Technical Service Information

GM 6T40 GENERATION III GENERATION III CHANGES

Figure 1

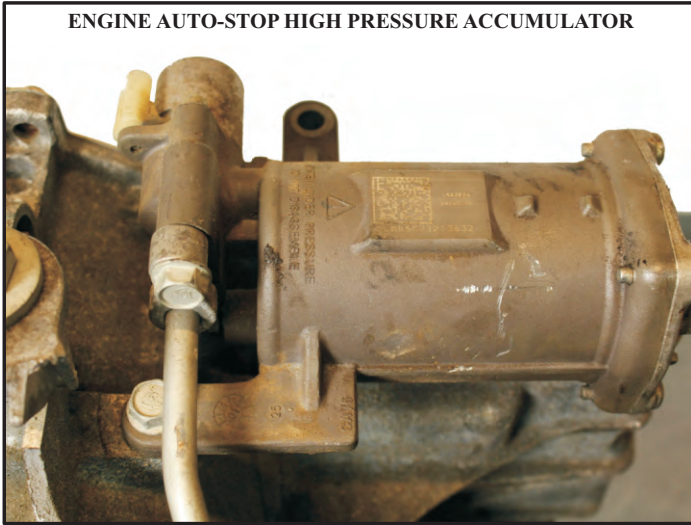
- (1) The addition of an externally mounted solenoid operated high pressure accumulator to provide clutch operating pressure for vehicles equipped with the Engine Auto-Stop feature (figure 1).

Figure 2

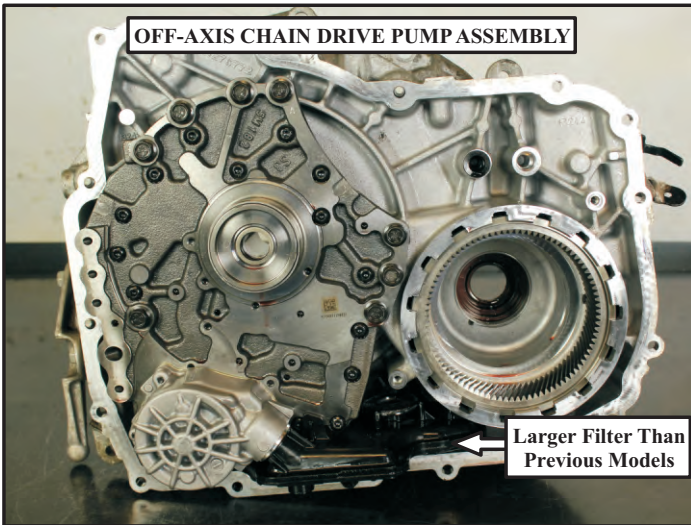
- (2) The torque converter housing was changed to accommodate the off axis chain driven pump assembly that is now mounted to it and to provide oil passages for the new pump design (figure 2).

- (3) The sump filter changed dimensionally to 5½ inches wide and 7¾ inches long (figure 2).
- (4) The pump assembly now consists of a variable vane type pump, fluid pump cover, a fluid pump plate, a fluid pump body which contains TCC and pressure regulation valves, a drive chain, and a drive and driven sprocket, see figures 3, 4, 5, 6 and 7.

Figure 10

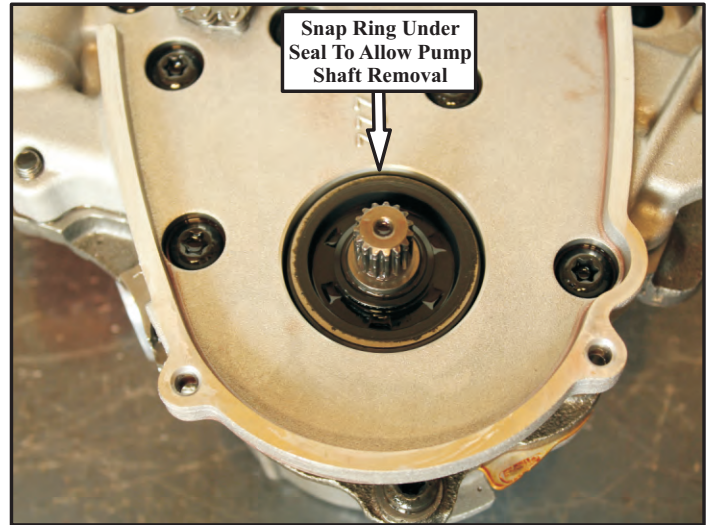
- (5) Transmission Pump Assembly torque specs and tightening sequences are provided in figures 8 and 9.
- (6) The pump assembly has a front seal that must be removed to gain access to the fluid pump shaft snap ring (figure 10).

Figure 11

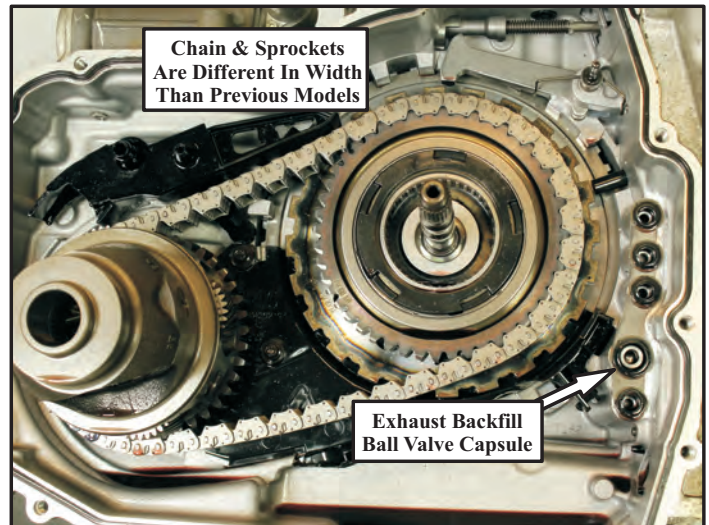
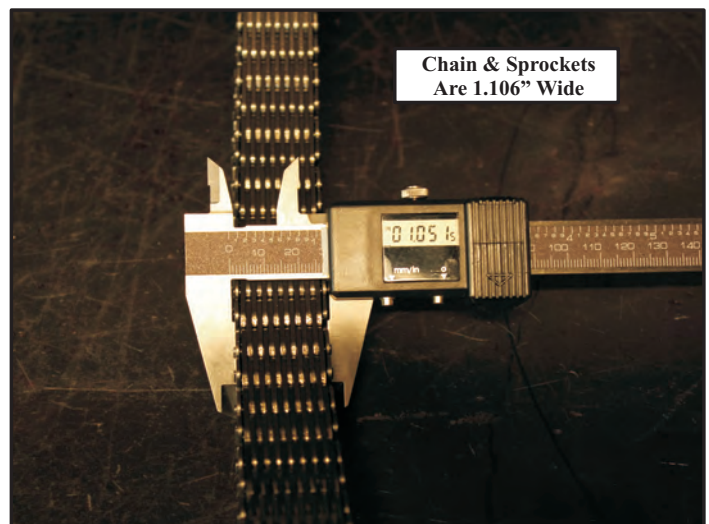
- (7) The transmission drive chain is now 1.106 inches wide and drive and driven sprockets that accommodate the chain width (figures 11 and 12).
- (8) The transmission case is deeper to accommodate wider parts (figure 11).

Figure 13

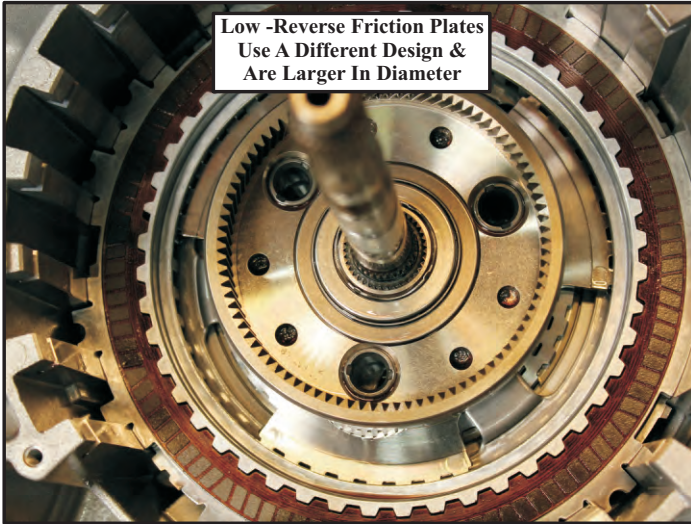
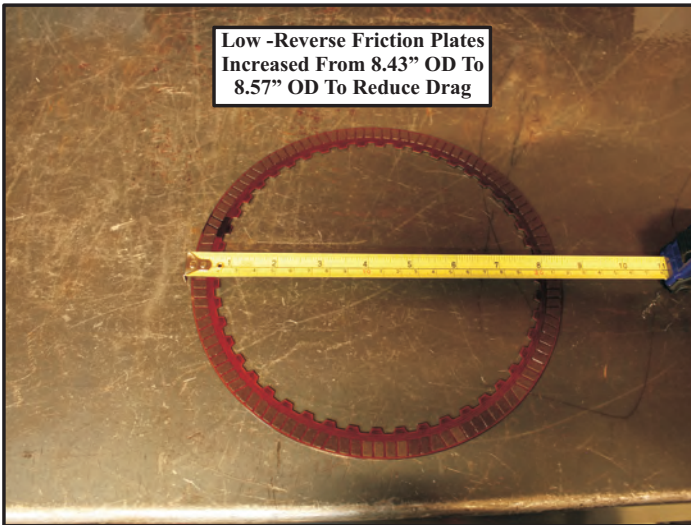
- (9) The low reverse friction plates have the outside diameter increased from the previous 8.43 inches to 8.57 inches to reduce drag. The friction material also changed to what is called a DOT type (figures 13 and 14).

Figure 16

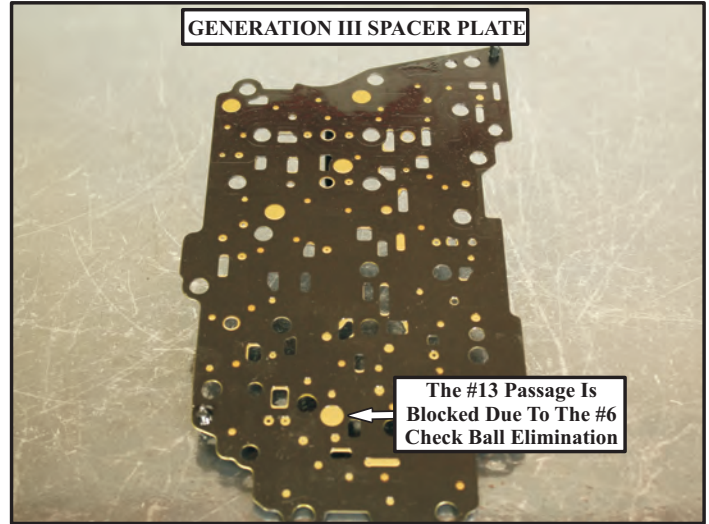
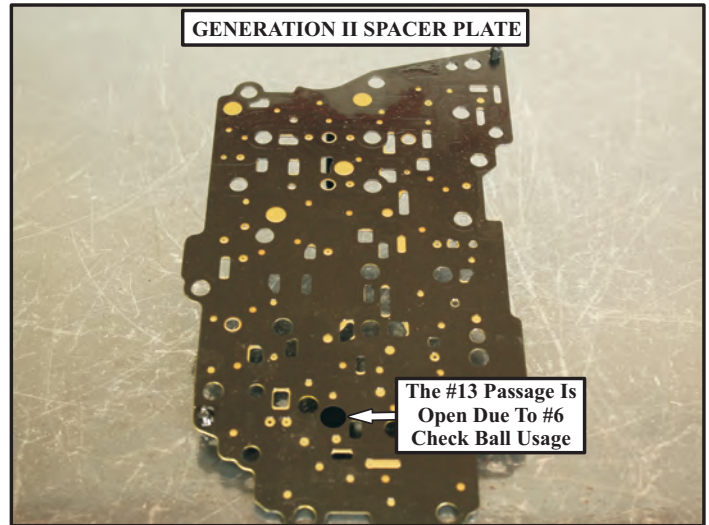
- (10) The main control valve body has the #6 check ball eliminated which is used in the hybrid application only (figure 15).
- (11) The Main control valve body to transfer spacer plate has eliminated the #13 passage (figures 16 and 17).

None of the above parts will back service any previous models with the exception of the valve body assembly. Install the #6 check ball if the application requires it and make certain the #13 passage in the spacer plate is open.

Figure 19

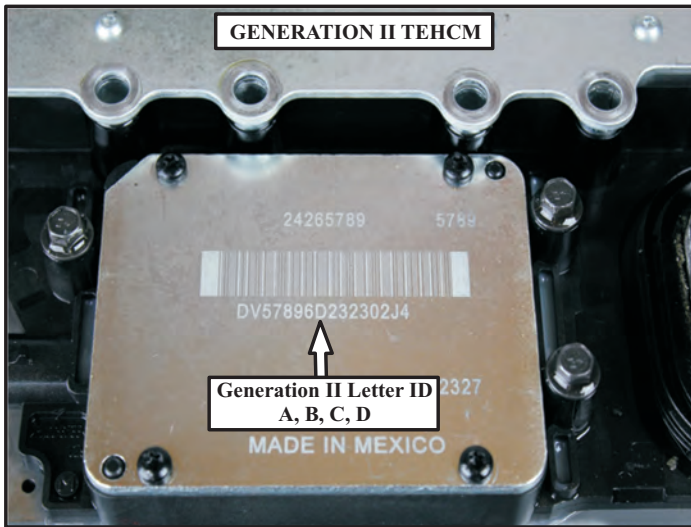
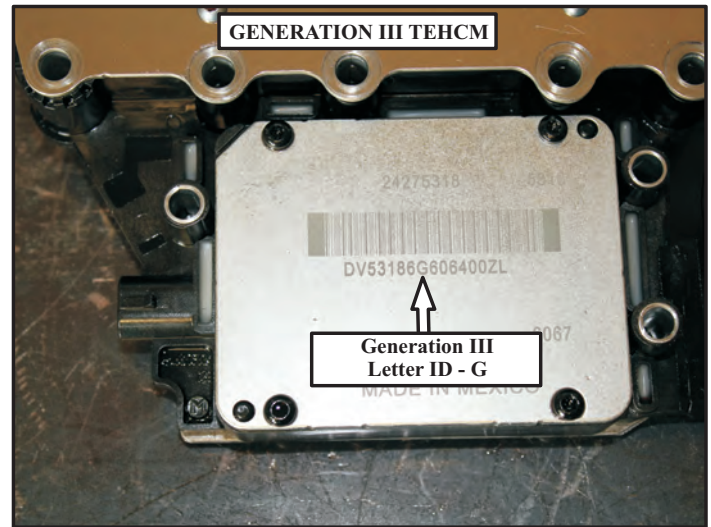
- (12) The valve body transfer plate is shown in figure 18. Small parts are identified and have not changed from the Generation II design level.
- (13) The Generation III TEHCM has new identification letters as compared to the Generation II (figures 19 and 20).
